BEFORE AN INDEPENDENT HEARINGS PANEL
APPOINTED BY THE SOUTH WAIKATO DISTRICT COUNCIL

UNDER	the Resource Management Act 1991
IN THE MATTER	of an application under s 88 of the Act
BY	**SUBDIVISION AT 597 HORAHORA RD**
PARTY	Bates Family Trust

VERBAL STATEMENT OF SHANNON BRAY

Development Layout Schematics

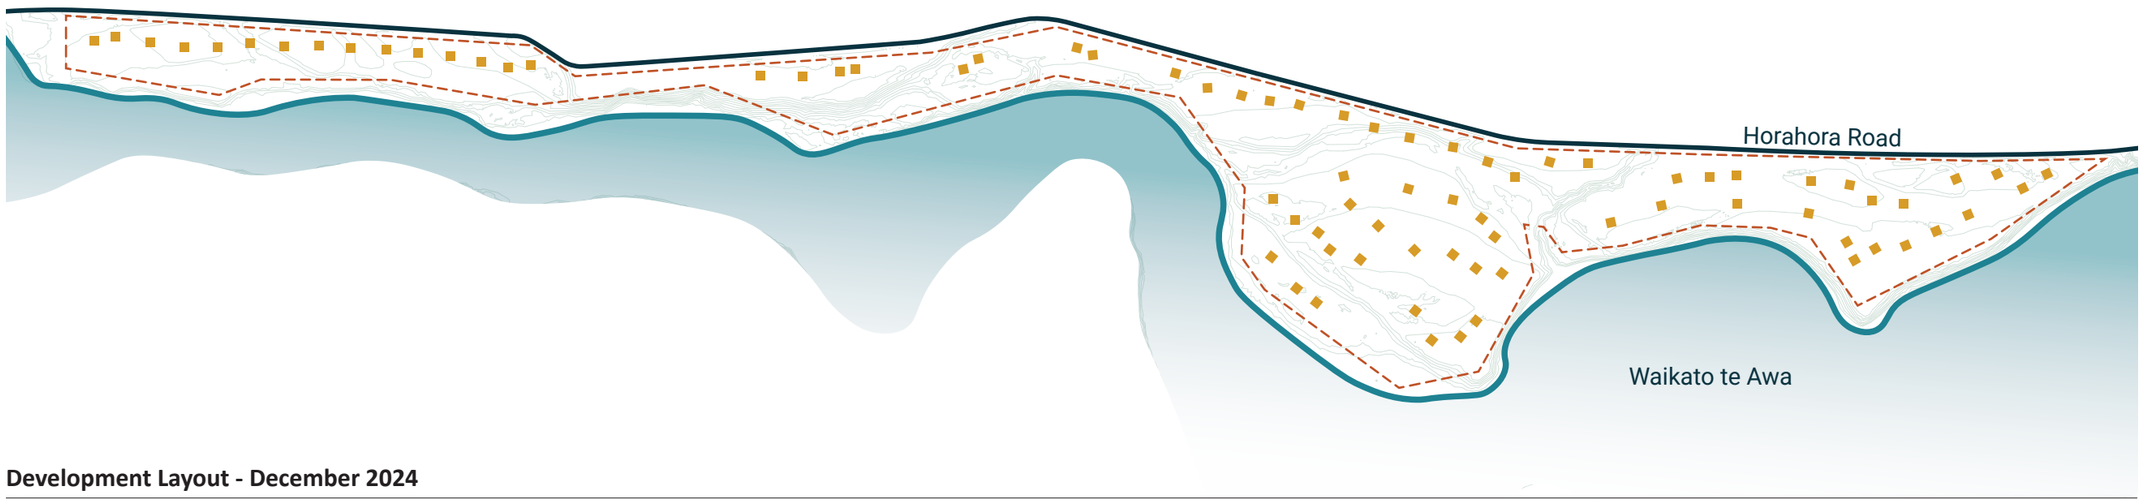
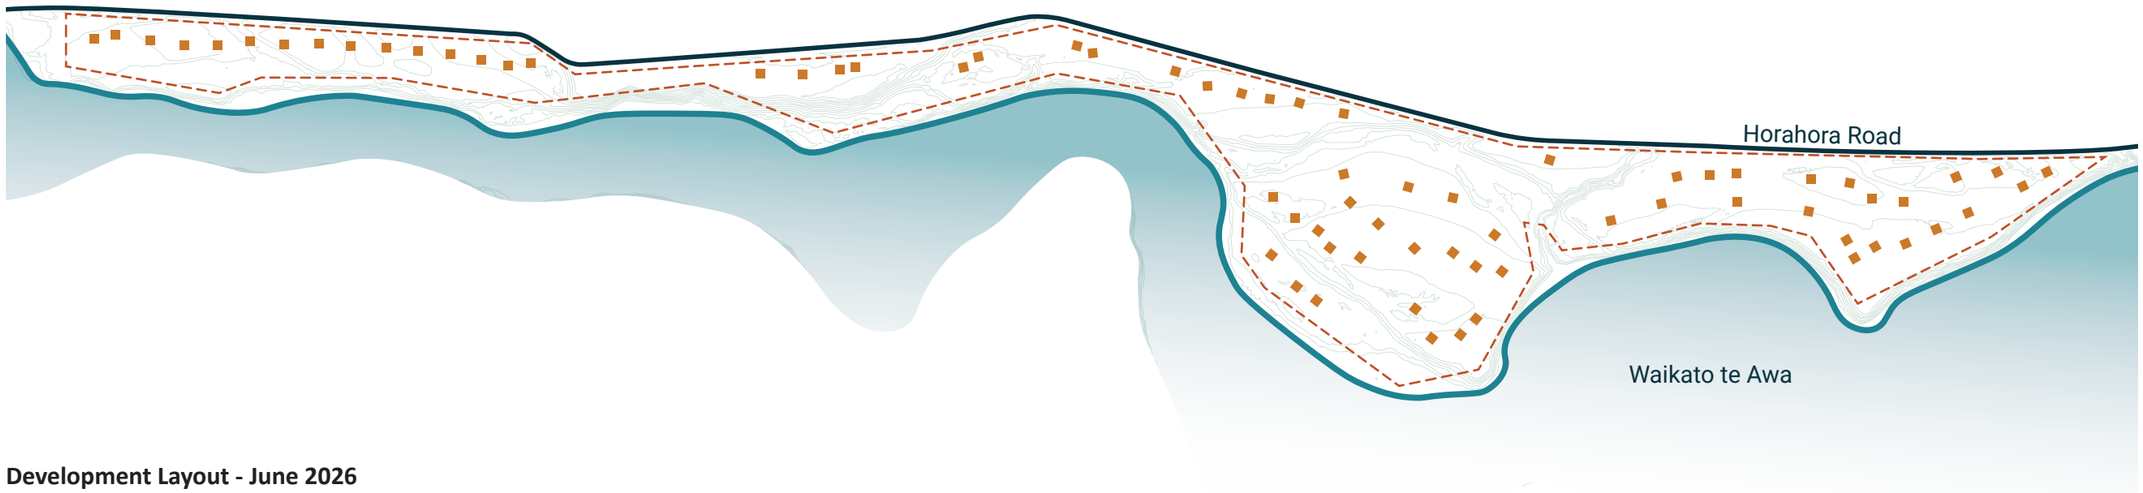
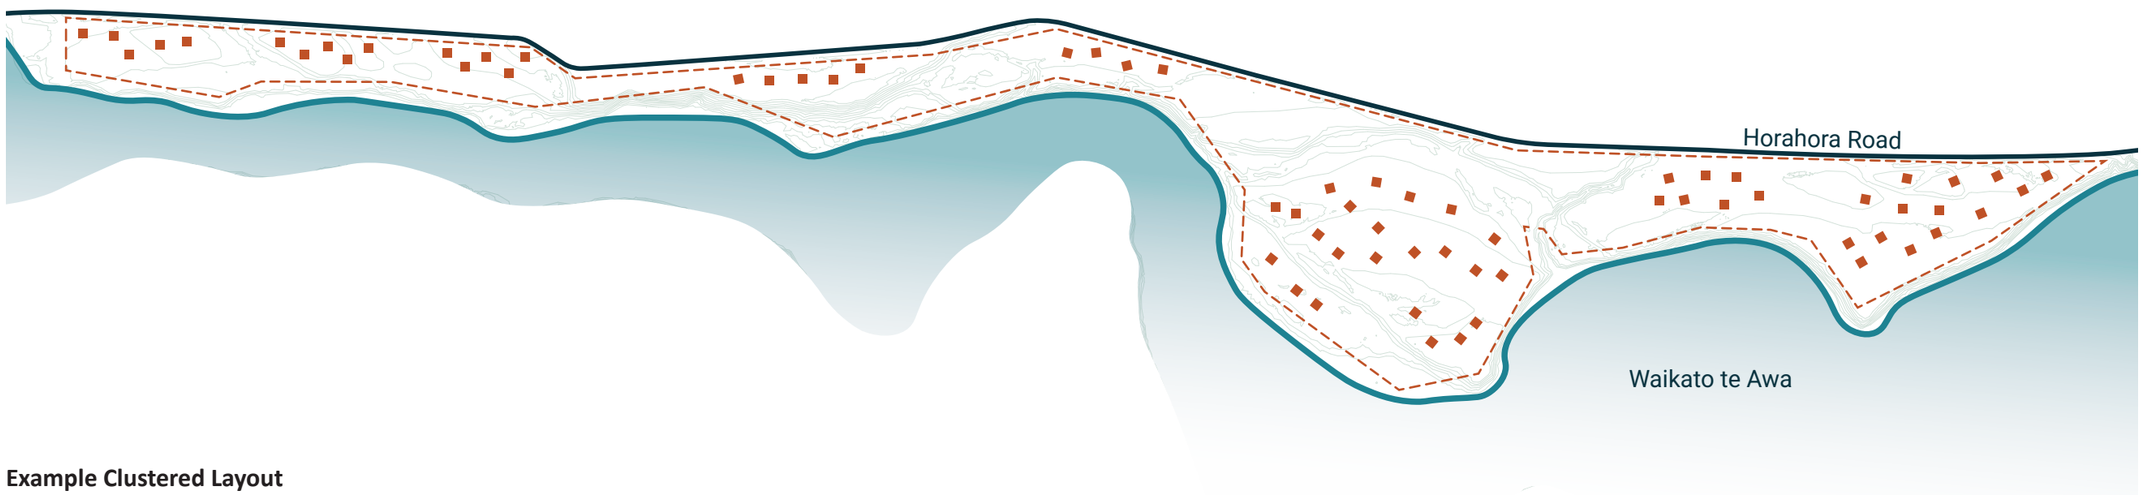
[2] Before turning to my main statement, I would like to make two corrections to my evidence. The first correction concerns Figure 1, for which I provide a revised version.

[3] The purpose of Figure 1 was to strip away some of the detail and allow the underlying distribution of development to be more readily understood. In preparing the example clustered layout, I included indicative landscape greening to demonstrate the opportunity to create gaps in the development. On reflection, I consider that greening introduced an unnecessary visual bias into the comparison that is not reflected across the Applicant's layouts.

[7] In preparing my original Figure 1, I admit to having been relatively conservative in Stage 1 and did not show substantial change in that area. However, in my March meeting with the Applicant I did present a simple pencil scheme that explored somewhat-triangular lots as one way of achieving greater clustering in

this area. That arrangement allowed groups of dwellings to be brought closer together while retaining the opportunity for individual lots to maintain views towards the river. This allowed greater clustering and more deliberate gaps between groups of the development. I have updated Figure 1 to demonstrate how this might be possible.

opinion, the underlying distribution of residential occupation remains substantially continuous (as illustrated by my Figure 1), and planting and other controls do not resolve that concern.

[4] I have therefore removed that greening. The revised figure is intended to show just the spatial difference between the proposed distribution of development and an example of a more deliberately clustered arrangement.

[5] As I made clear in my evidence, the example is schematic. It is not an alternative subdivision design and has not been tested against all of the site's planning, infrastructure or physical constraints. It is simply intended to illustrate the landscape principle I am describing.
